Access Compliance Report

Public Rights-of-Way (Curb Ramps)

Intersection ID: 52311	Main Street: IMPATIEN_DR	Cross Street: LUPINE_CT	Location: SE
ADA ID: 99EC3F9F89F7	Ramp Type: PerpDiag	Initial Pass/Fail: Fail	Overall Compliance: No
			Severity Score: 21.25

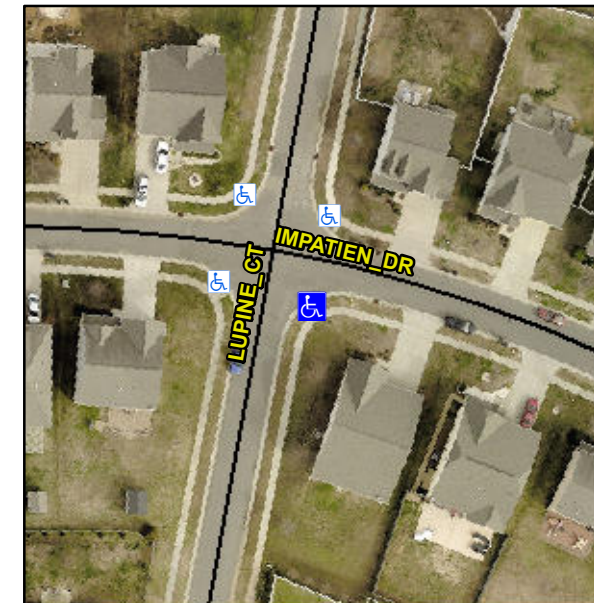
Not Found, R304.5.1, R304.5.3

Compliance	Description	Data	Compliance	Description	Data
N/A	Ramp Length (in)	70.0	Yes	Ramp Slope (%)	6.2
No	Ramp Width (in)	47.0	No	Ramp XSlope (%)	5.6
N/A	Flare Type LT	N/A	N/A	Flare Type RT	N/A
N/A	Flare Slope LT (%)	N/A	N/A	Flare Slope RT (%)	N/A
N/A	Flare Traversable LT?	N/A	N/A	Flare Traversable RT?	N/A
N/A	Landing Length (in)	N/A	N/A	DWS Provided?	N/A
N/A	Landing Width (in)	N/A	N/A	DWS Contrast?	N/A
N/A	Landing Slope (%)	N/A	N/A	DWS Length (in)	N/A
N/A	Landing X Slope (%)	N/A	N/A	DWS Full Width?	N/A
N/A	Landing Curb? (Y/N)	N/A	N/A	DWS Offset (in)	N/A
N/A	Shared Landing?	N/A			
N/A	Gutter Ponding?	N/A	N/A	Gutter Slope (%)	N/A
N/A	Gutter Lip Ht (in)	1.0	N/A	Gutter X Slope (%)	N/A
N/A	Painted X Walk1?	No	N/A	Painted X Walk2?	No
	X Walk 1 Direction	To N		X Walk 2 Direction	To W
N/A	X Walk 1 Width (in)	N/A	N/A	X Walk 2 Width (in)	N/A
	X Walk 1 Slope (%)	3.2		X Walk 2 Slope (%)	3.3
	X Walk 1 X Slope (%)	2.1		X Walk 2 X Slope (%)	1.1

Remove & Replace Curb Ramp With Two New Directional Ramps or Equivalent.
